Staff Summary Report

SUBJECT: Hold a public hearing for an Amended Planned Area Development Overlay and Development Plan Review for PHASE 2 OF TEMPE GATEWAY located at 222 South Mill Avenue.

DOCUMENT NAME: DRCr_Phase 2TempeGateway_062607 **PLANNED DEVELOPMENT (0406)**

RECOMMENDATION: **Staff – Approval, subject to conditions (1 - 33).**

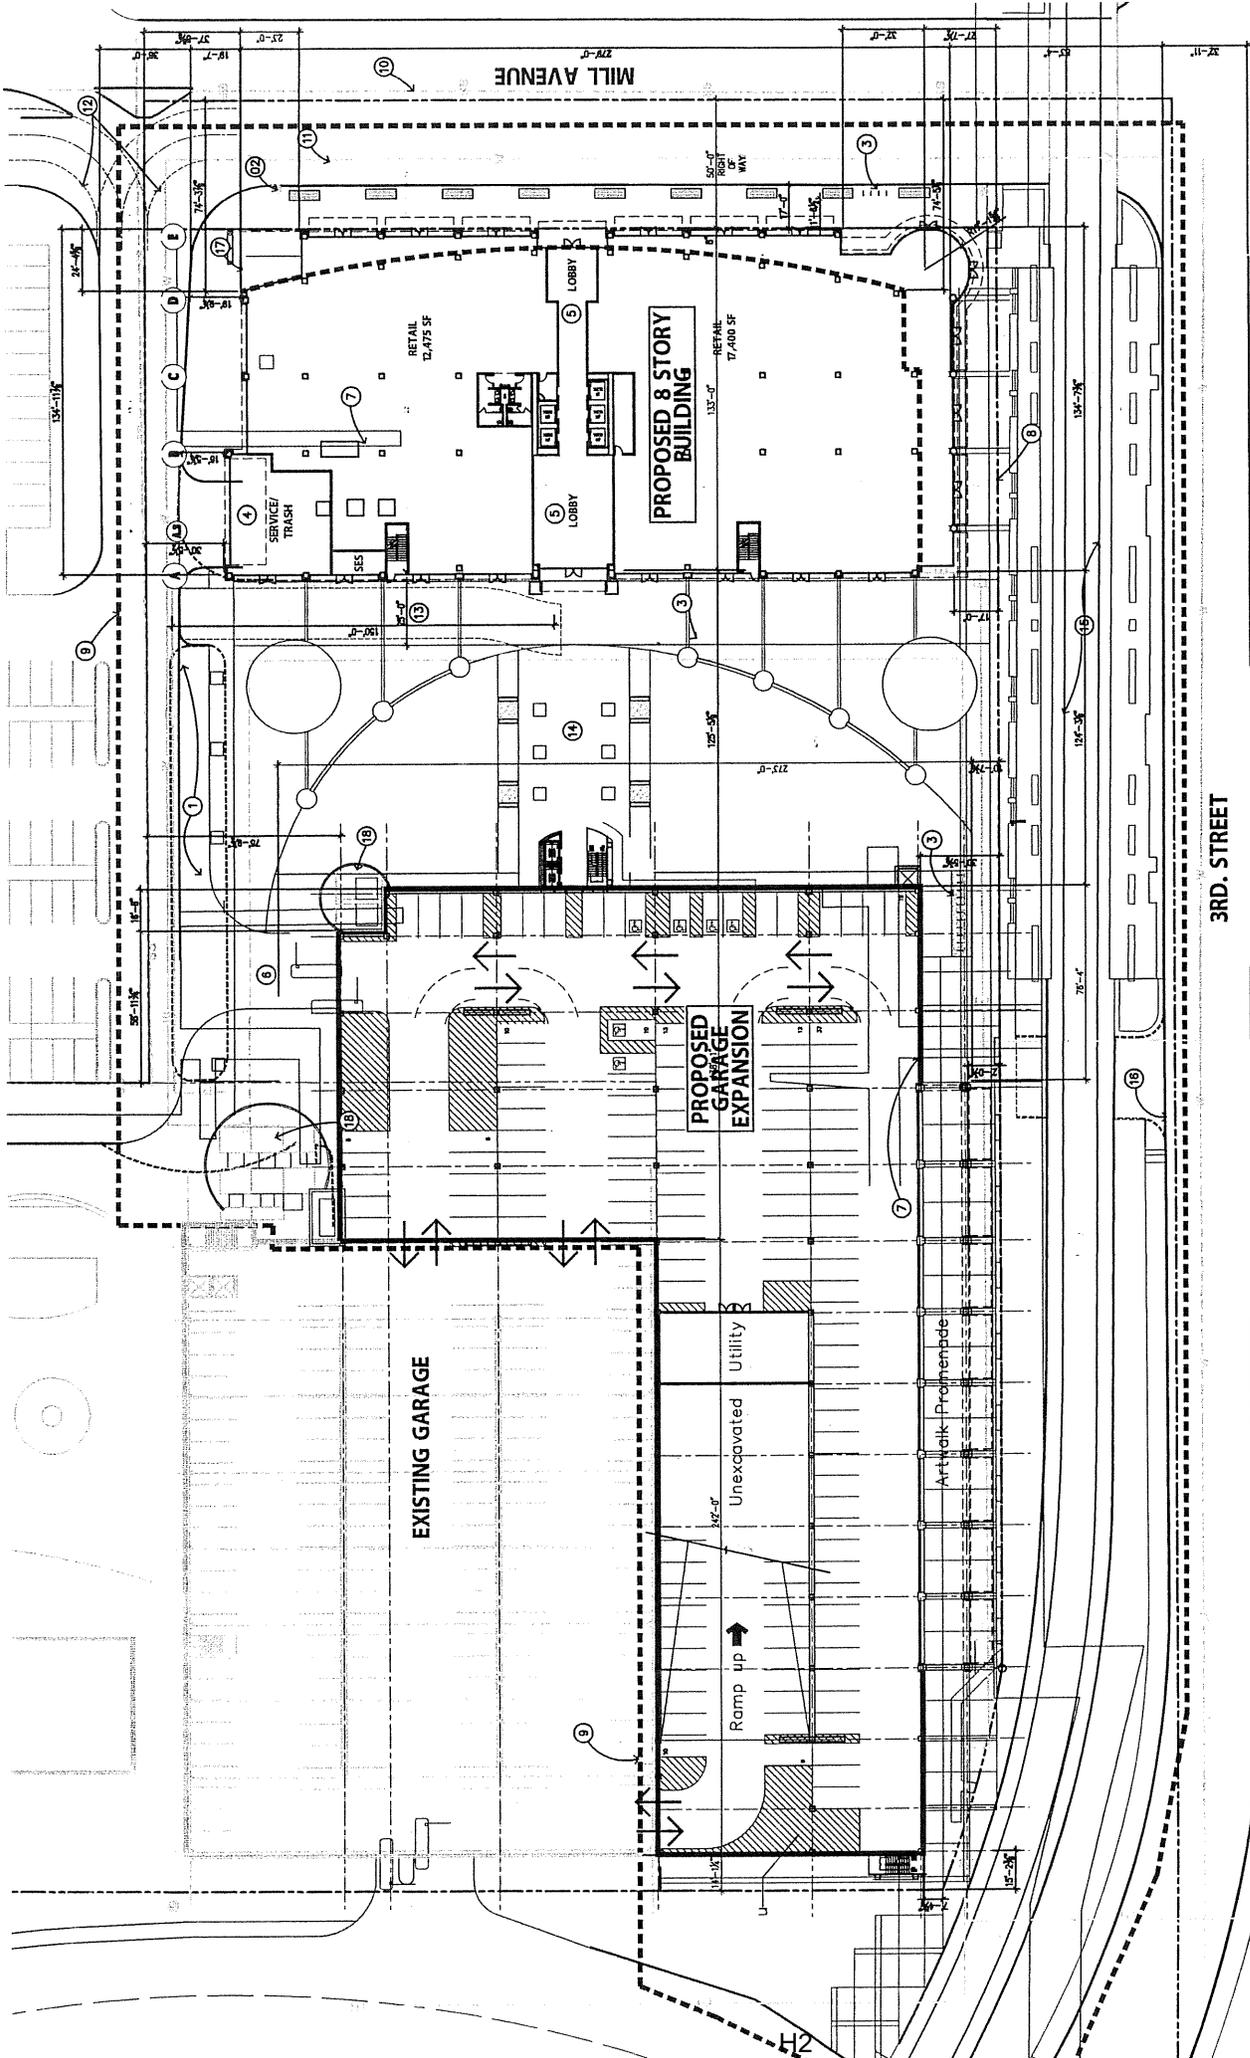
4. As indicated on the site plan, delete the driveway to 3rd Street on the Maple alignment. Do not consider this as an exit only drive, coordinated with trains, as is indicated in the applicant's Letter of Intent.
5. As a reflection of the presence of the Light Rail station and the vehicle drive lane reduction on Mill Avenue completed earlier this decade, provide 34 bike parking spaces (representing the amount of bike parking for retail and office use for Phase 2) in addition to the 50 bike parking spaces allowed for the entire site by variance SBD 97-91.

6. Clearly define fire lane and turnaround to the extent indicated on the March 14, 2007 Site Plan Review mark-up. Provide pavement design that is suitable for high load traffic for full length of lane. This lane may be used for routine retail deliveries in addition to emergency access; the 150'-0" long lane indicated on the site plan is inadequate for this purpose. Ensure that there is at least a 20'-0" horizontal width and a 14'-0" vertical clearance above the fire lane surface for tree canopies or overhangs. Fire lane design subject to approval of the Fire Department (jim_walker@tempe.gov).

7. Sanitation:
 - a. Review the site plan with Public Works/Solid Waste (maryhelen_giustizia@tempe.gov or ron_lopinski@tempe.gov) and verify refuse pick up truck access and maneuvering to compactor north of Phase 2 building. Modify compactor enclosure position and alignment in overall site layout if necessary.

8. At northwest corner of Phase 2 office building, provide service yard walls that are at least 8'-0" tall as measured from adjacent grade and are at least the height of equipment or storage items being enclosed, whichever is greater. Verify height of equipment and mounting base to ensure that wall height is adequate to fully screen the equipment. Locate electrical service entrance sections inside the adjacent electrical room, as indicated. Do not position electrical equipment other than the transformers outside. Construct gates of steel mesh to allow visual surveillance when up close. Coordinate gate hardware with emergency ingress and emergency egress requirements of Fire and Building Safety.

9. On-Site Paving:
 - a. Provide upgraded paving at each 2nd Street driveway apron consisting of clay unit paving. Match paving used in the downtown district. Extend unit paving in the driveways from the back of the accessible public sidewalk bypass to 20'-0" on site and from curb to curb at the drive edges.

WEST ELEVATION

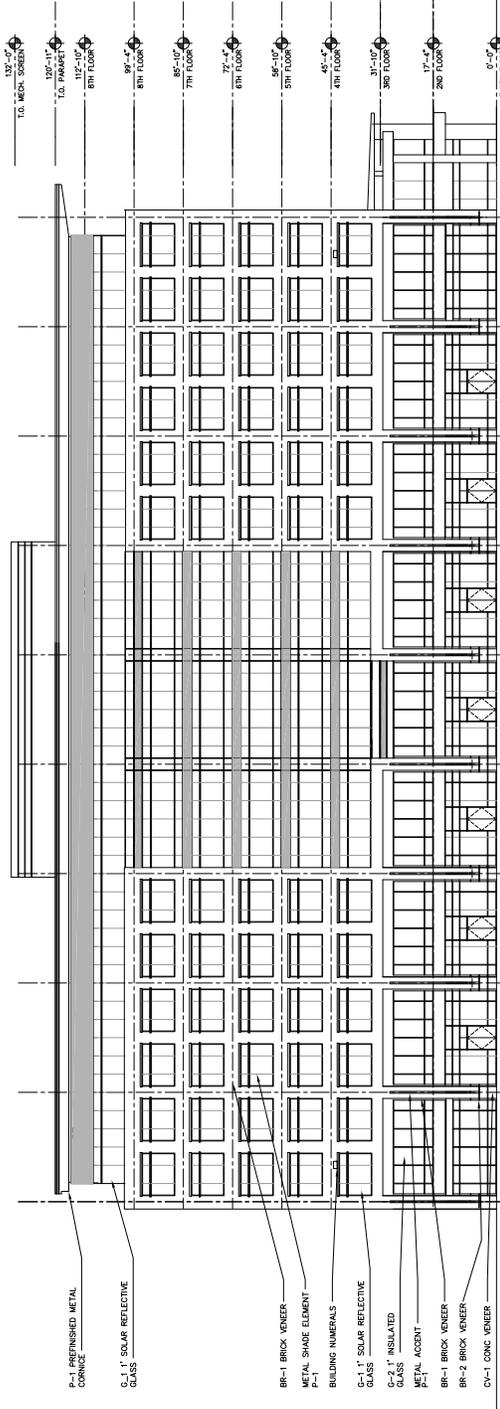
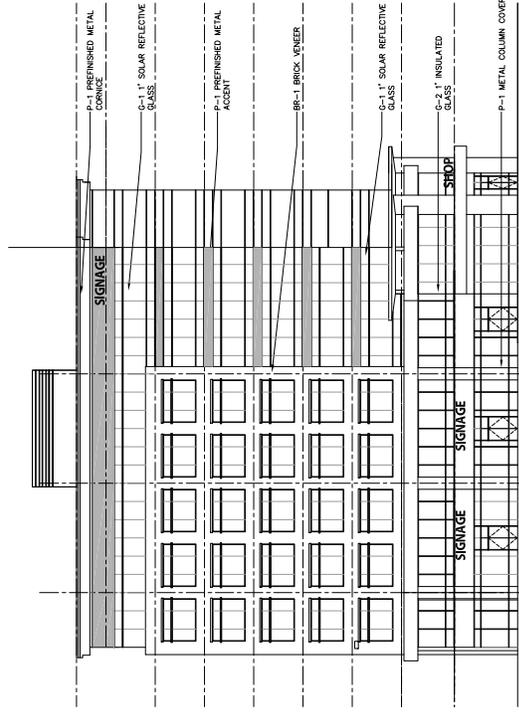
18. Provide increased detailing such as two color brick pattern accenting in conjunction with the stone water table at the base of the Phase 2 Office Building elevations. Extend the two color brick pattern up to the level of the third floor on all sides to strengthen the pedestrian character for the retail entrances, the loft offices and the storefronts. Use of brick detailing on the wall surfaces in conjunction with the adjacent paving surfaces that may entice pedestrians to pause and look rather than hurry by is encouraged.

L 1.0
 LANDSCAPE
 PLAN

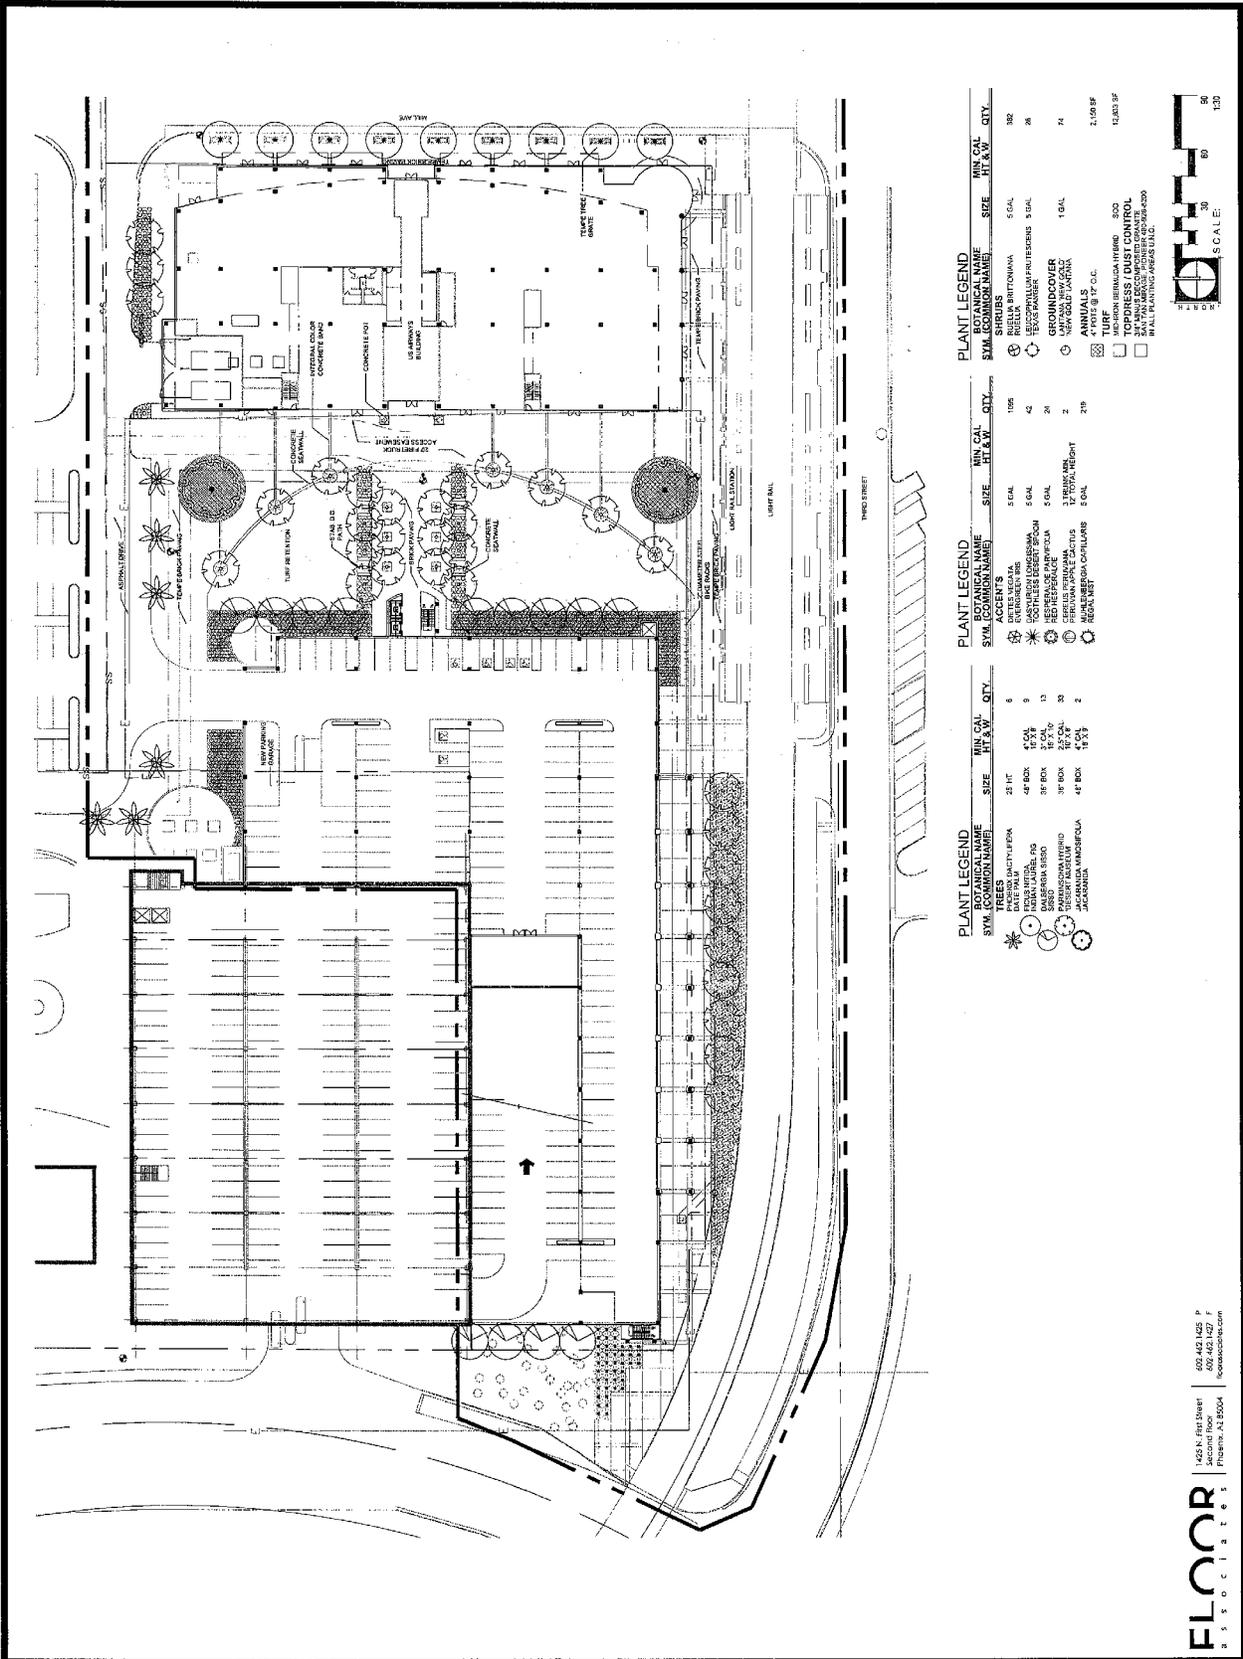
27. Salvage the Palo Verde and Olive species on site. Retain these trees in place where possible, otherwise box these trees, remove from site and store in a nursery (either on site or in a remote location). Protect and maintain the boxed trees during construction. Incorporate the trees into the landscape site design. Placement of transplant trees in either Phase 2 or Phase 1 site or frontage planting areas is acceptable.

31. Top dress planting areas with a ¾" minus decomposed granite application as indicated. Provide decomposed granite application of 2" uniform thickness. Provide pre-emergence weed control application. Do not underlay rock or decomposed granite application with plastic.
